PLAN CHANGE 92 – SUMMARY OF CHANGES TO RECOMMENDATIONS BASED ON COUNCIL EVIDENCE – 6 SEPTEMBER 2023

The purpose of this document is to update the recommended changes which were published in the following documents at the time of releasing the Section 42A report:

Attachment A – Recommended Changes to District Plan Maps

Attachment B – Recommended Changes to District Plan Text

467E Ōmokoroa Road - Recommended Significant Ecological Feature Change

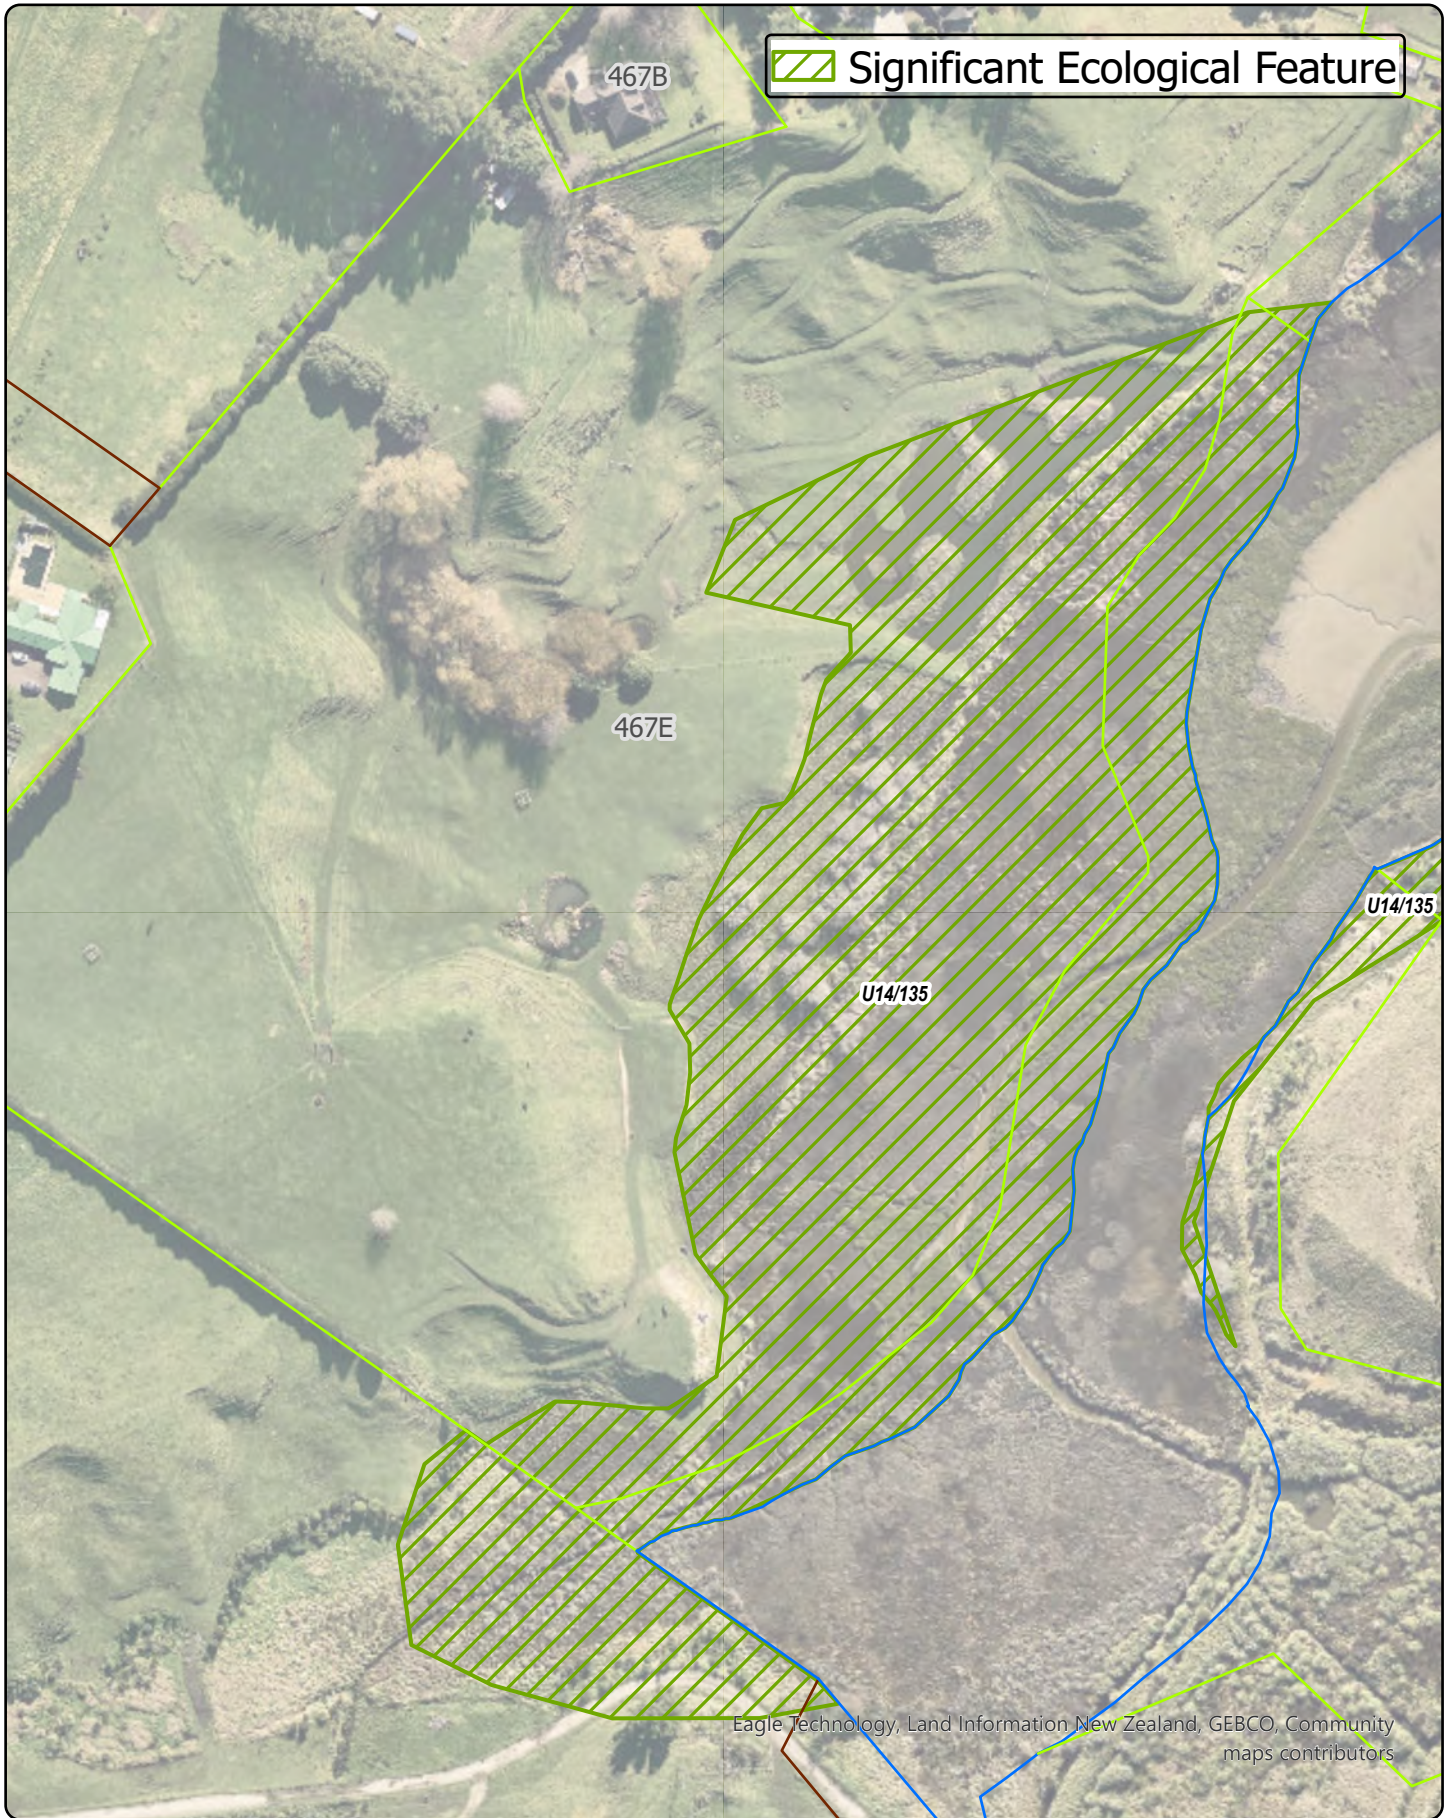
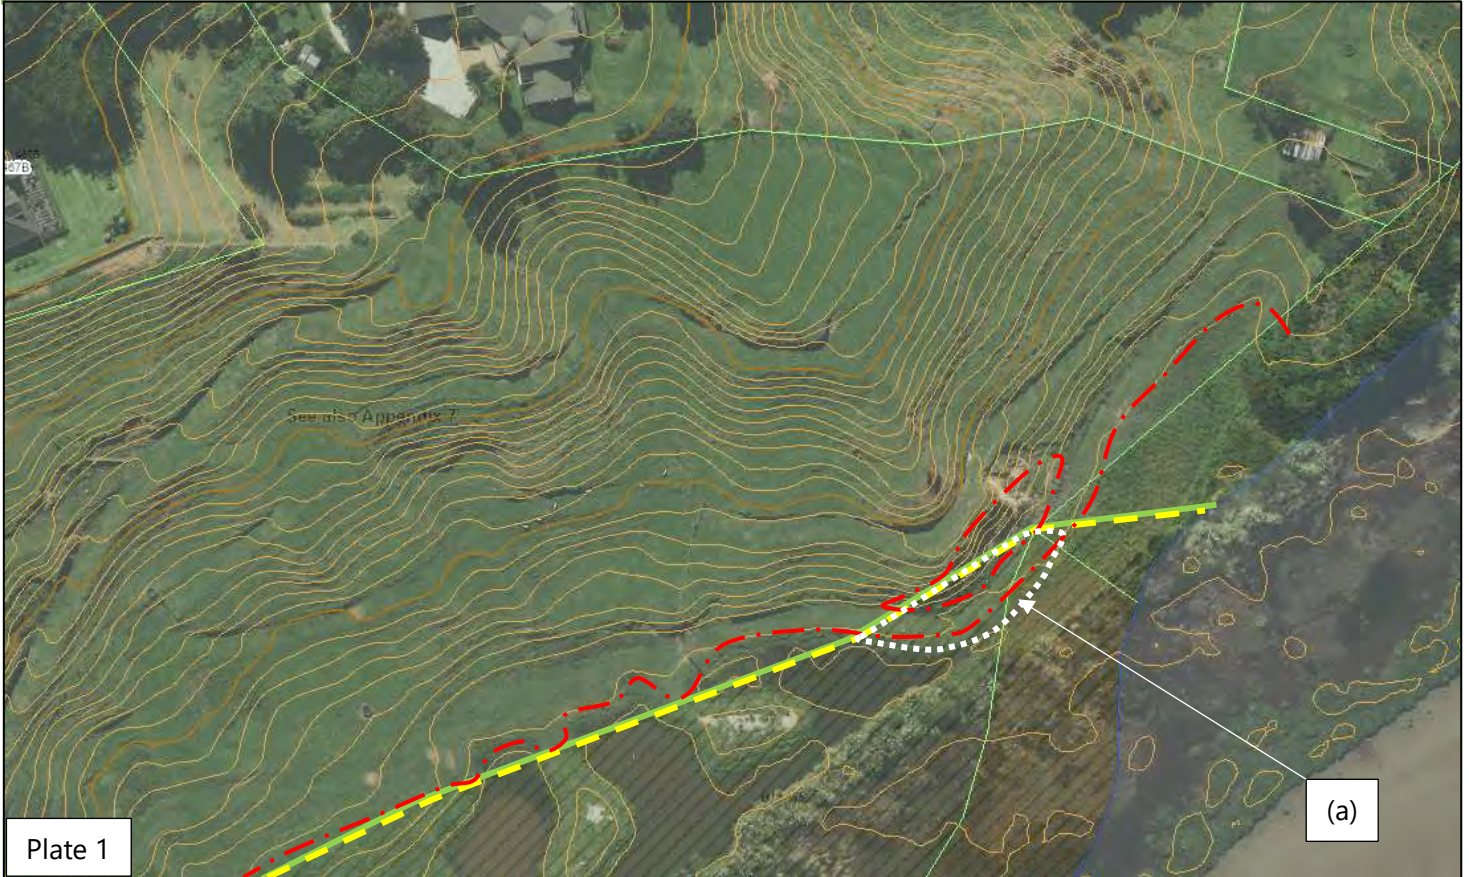
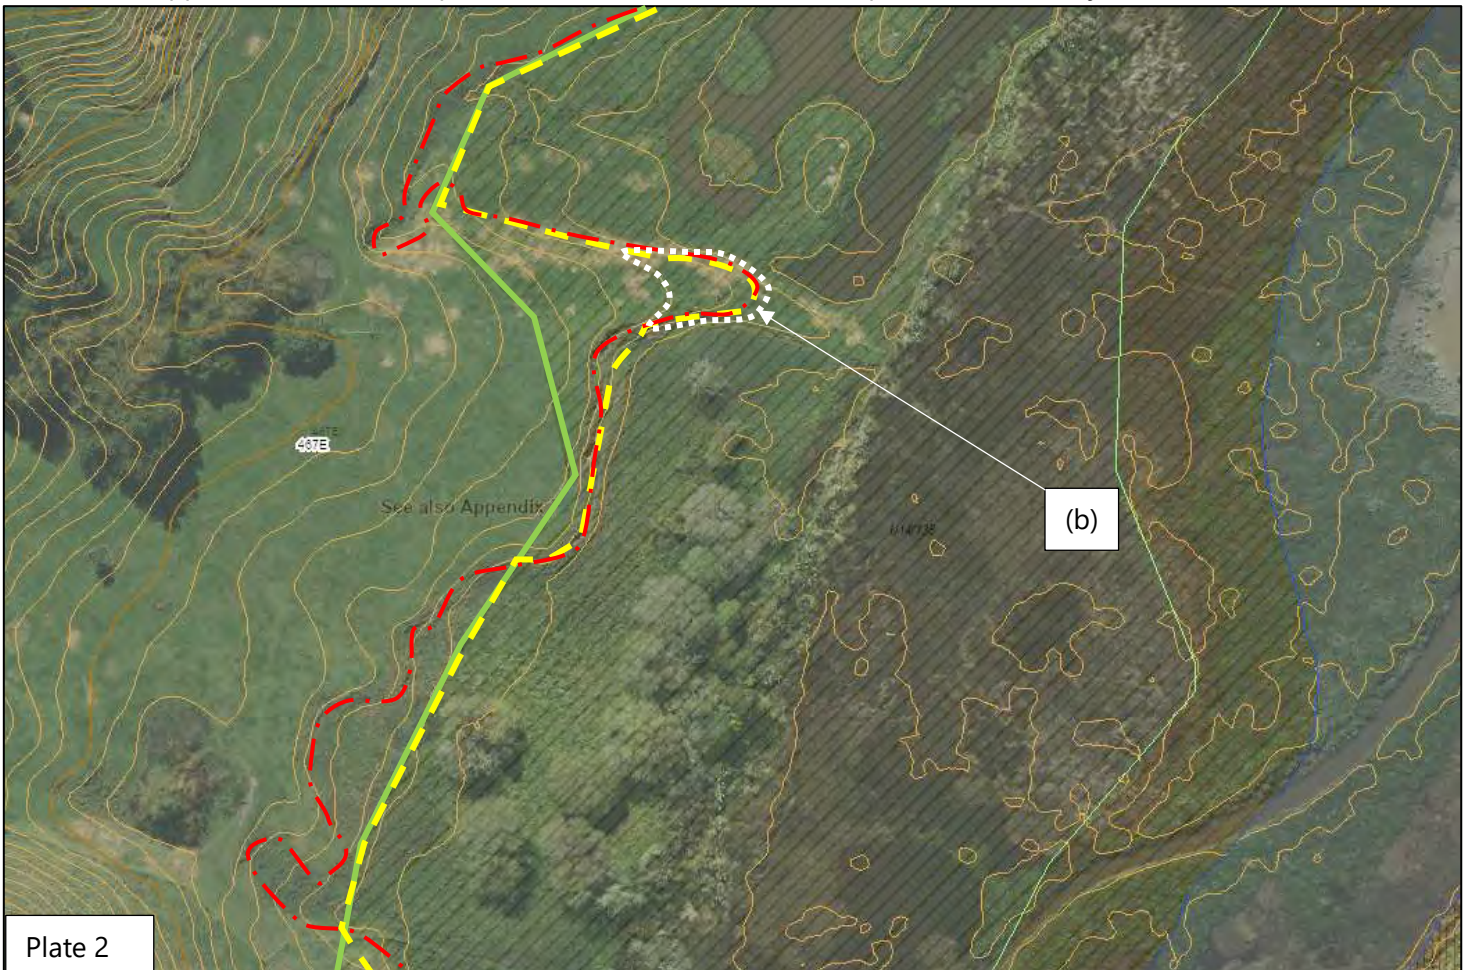
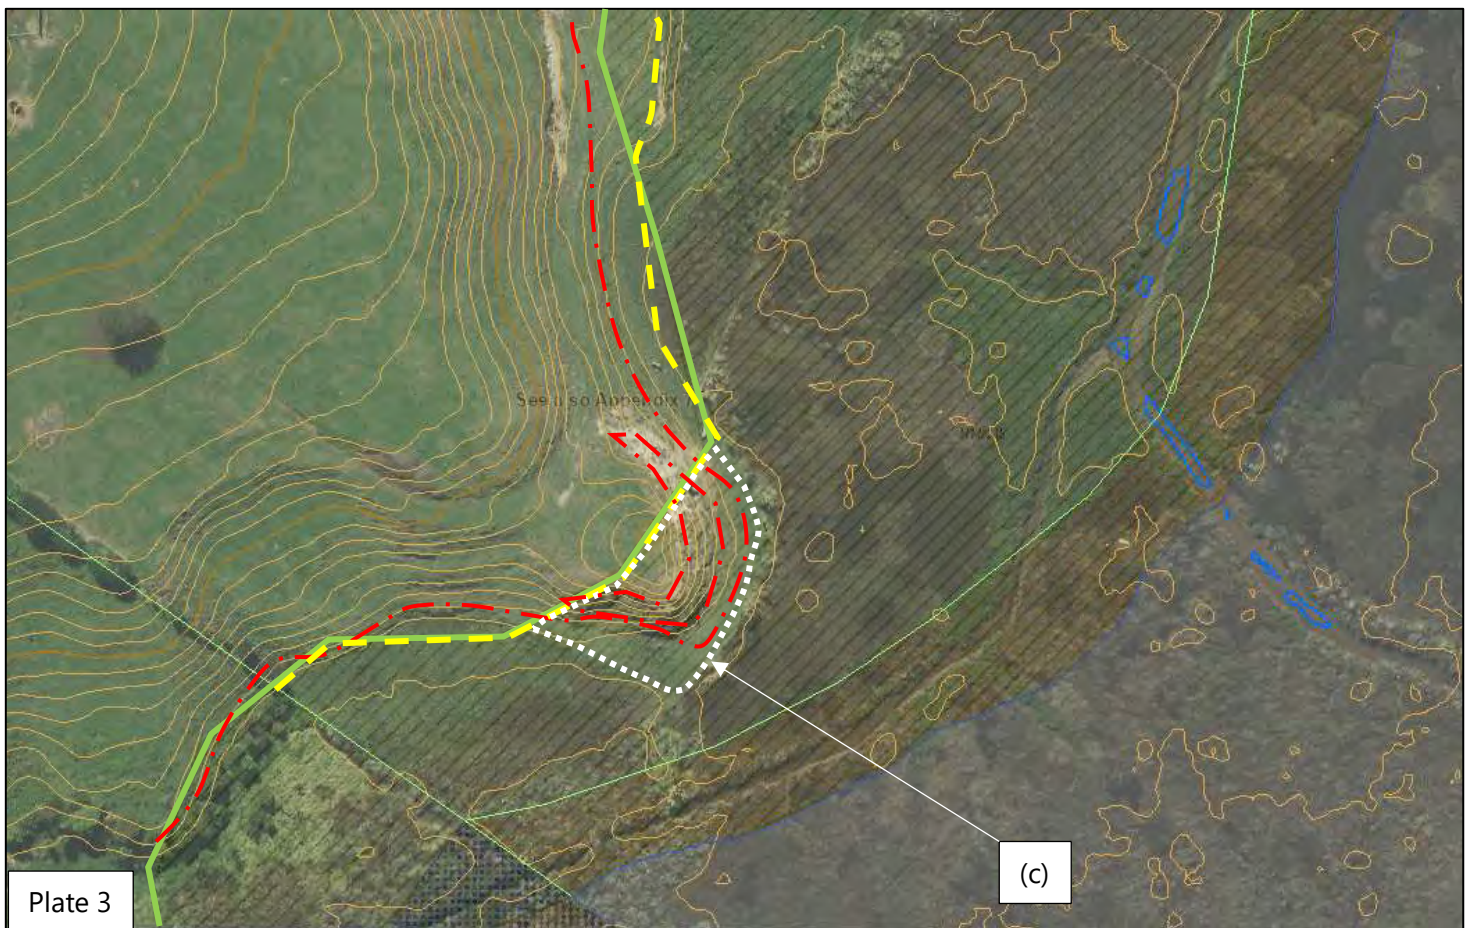
- **Ōmokoroa Plan Change 92 – Proposed Zoning Map:** Further amend the boundary of significant ecological feature U13/145, as it applies to 467E Ōmokoroa Road (M & S Smith) by removing the area shown as (b) in Plate 2 of the assessment from Nautilus Contracting Limited.

Note: Approx 25% of Area (a) above, as submitted by Mr & Mrs Smith, is within existing esplanade reserve, and when future subdivision happens a MHWS fix will place all of this within a 20m wide esplanade reserve adjustment.

Note: Area (b), as submitted by Mr & Mrs Smith, is to be landward of the revised DP SEF.

- In Plate 1 the DP SEF alignment remains unchanged. This recognises that: (i) some of Area (a), as submitted by Mr & Mrs Smith, is actually esplanade reserve; (ii) the balance would become esplanade reserve upon any future subdivision; (iii) some of the terrain has been modified; (iv) the steep batter alongside is unstable and should not be grazed or otherwise developed.

- In Plate 2 the DP SEF alignment can be adjusted to align with the extent of the wetland feature – which would develop in the absence of grazing – and which would reasonably closely align with the proposed Plan Change 92 Natural Open Space Zone (NOSZ). This supports Mr & Mrs Smith’s submission respecting Area (b).

- In Plate 3 the DP SEF alignment remains unchanged. This recognises that approx. half of the site is within the freshwater wetland feature – which would develop in the absence of grazing – and includes most of the very steep batter which is erosion prone. Upon future land subdivision all of this area would become esplanade reserve after MHWS refix. This alignment also accords with the NOSZ alignment referred to above. On balance, any ground within Area (c) which is not captured by wetland values or very steep erosion-prone terrain is somewhat insignificant. On that basis it seems meaningless to alter the DP SEF at this site.

- The proposed amendment of the District Plan SEF landward line is almost identical to the Plan Change 92 Natural Open Space Zone line. In is sensible for these to be generally consistent.
